Access Compliance Report

Public Rights-of-Way

(Curb Ramps)

Intersection ID: 48173	Main Street: E_12TH_ST	Cross Street: ALPHA_MILL_LN	Location:	N
ADA ID: 9B6268532BB1	Ramp Type: Perp	Initial Pass/Fail: Pass	Overall Compliance: No	Severity Score: 5
Codes/Mitigation Info/Possible Solution		Field Measurements/Component Compliance

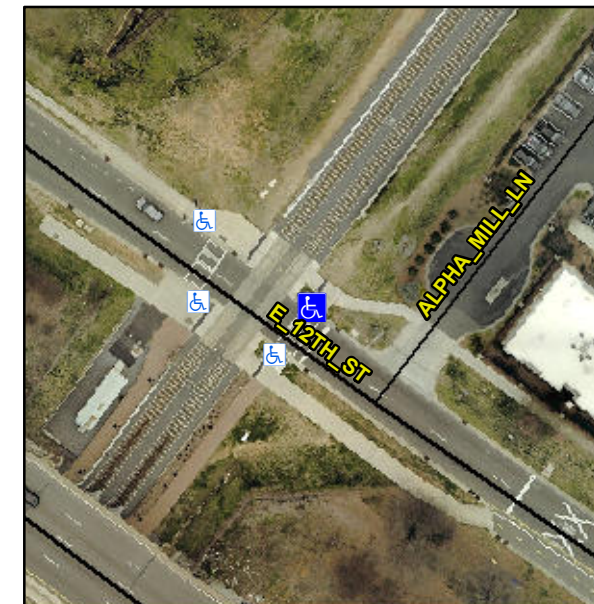
R304.5.4, R304.5.3

Remove & Replace Gutter.
